Airspace Change Proposal ACP-2020-064

Summary of Stakeholder Engagement and Final Proposal

Skylift UAV Limited
Version 2.0
16/11/2020

DIAGRAM 1 – Proposed Zone Revision

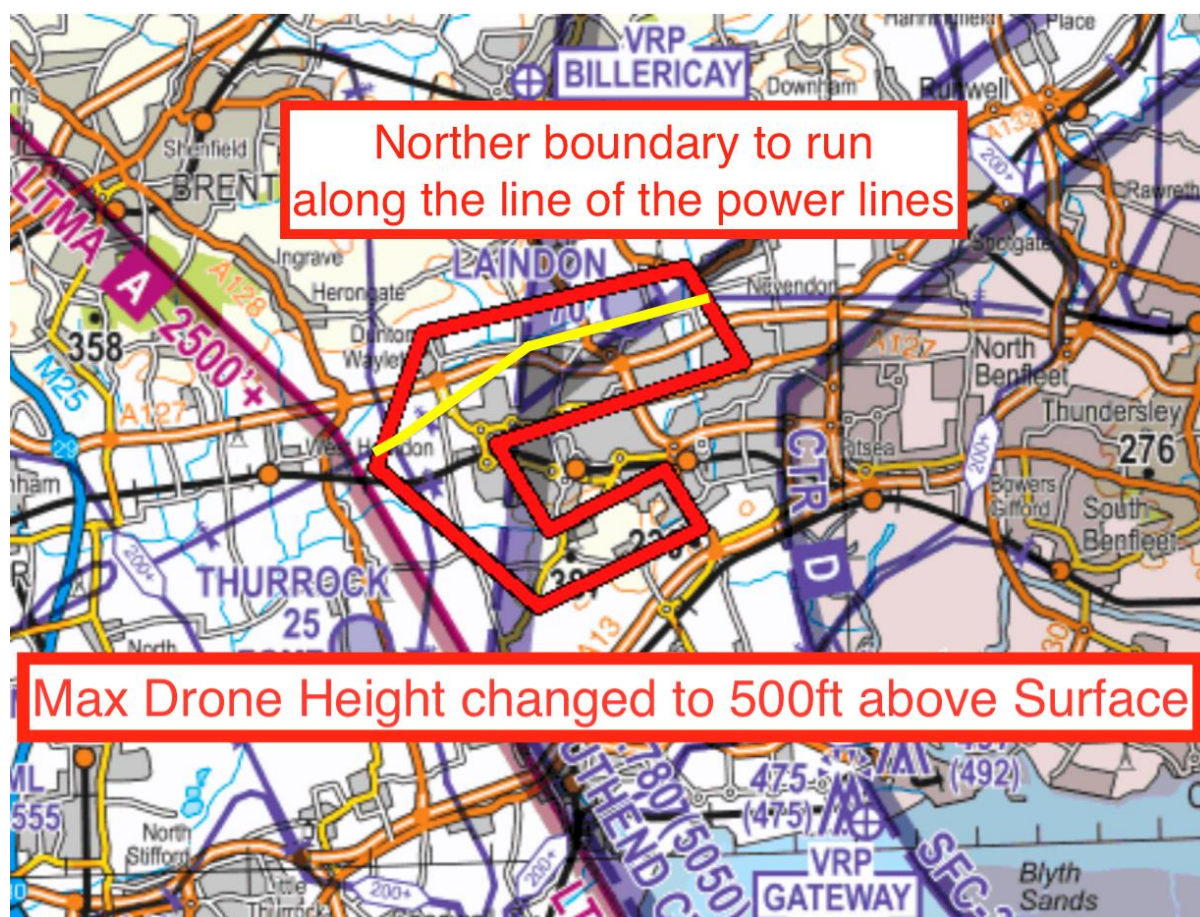
The TDA should be changed as per Diagram 1

- a. The northern limit of the zone to follow the power lines
 - i. **REASON** - this would physically separate drones and Laindon traffic and remove the need for an airborne crossing service.
- b. The zone height limit should be set to 500ft above the Surface as per existing drone flying rules.
 - i. **REASON** - "Skylift UAV Ltd" commercial drones should never be permitted to go over 500ft above surface level on any route as going any higher would intrude into the generally used recreational airspace.

Following this proposal, Skylift UAV met with the pilots at Laindon, including Pilot B, on 16/10/2020 and came to an agreement as per section 7 in the main report.

DIAGRAM 2 – Proposed Zone Revision

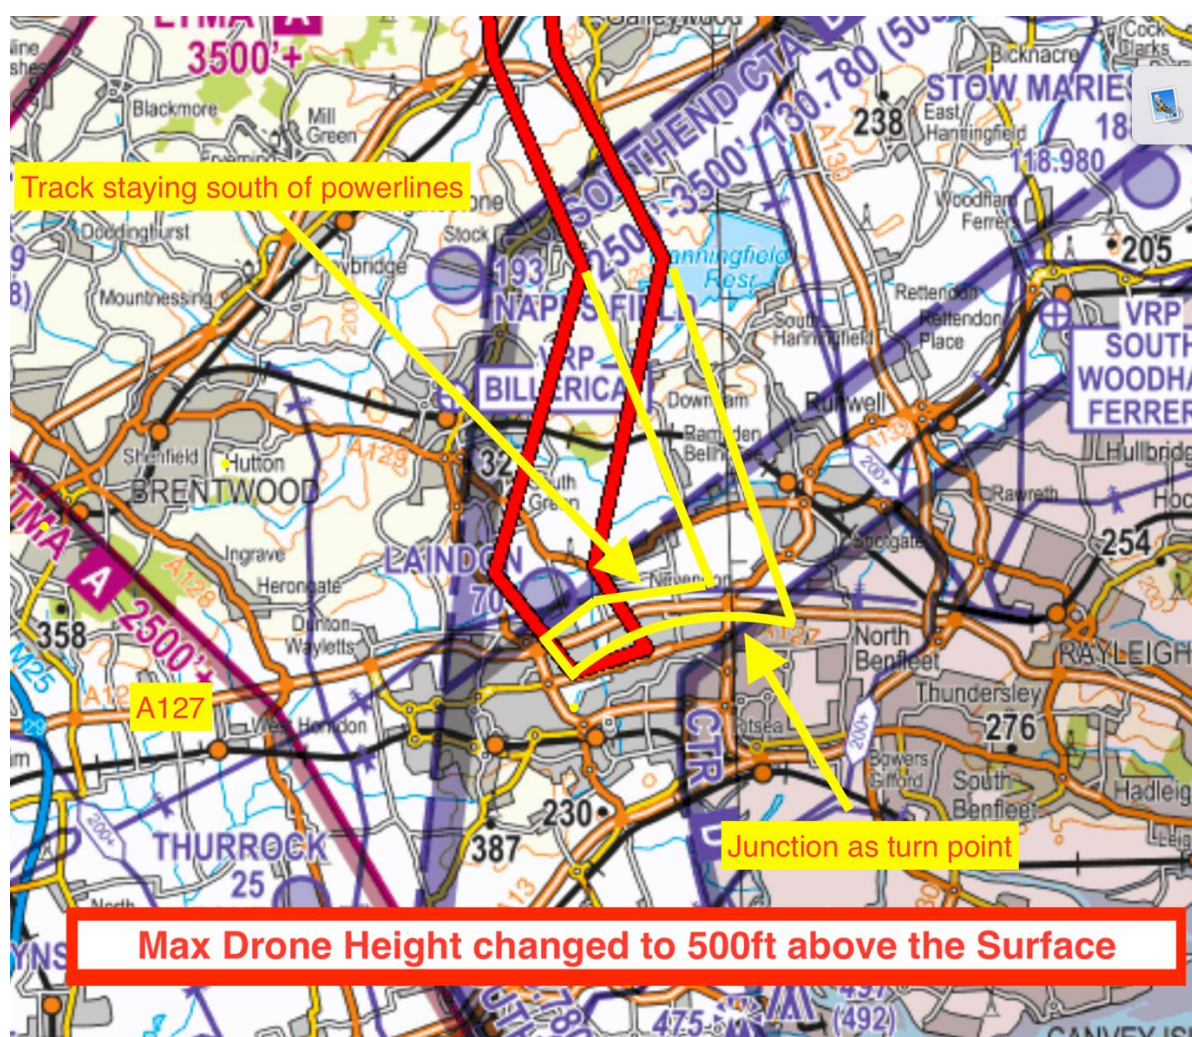
The zone must be changed as per Diagram 2

- a. The zone would follow the power lines 1.5 miles east using the A127 Nevendon road junction as a datum for the zone centre line
 - i. **REASON** - this would keep a separation of Drone and Aircraft
- b. The zone height limit should be set to 500ft above the Surface as per existing drone flying rules.
 - i. **REASON** - “Skylift UAV Ltd” commercial drones should never be permitted to go over 500ft above surface level on any route as going any higher would intrude into the generally used recreational airspace
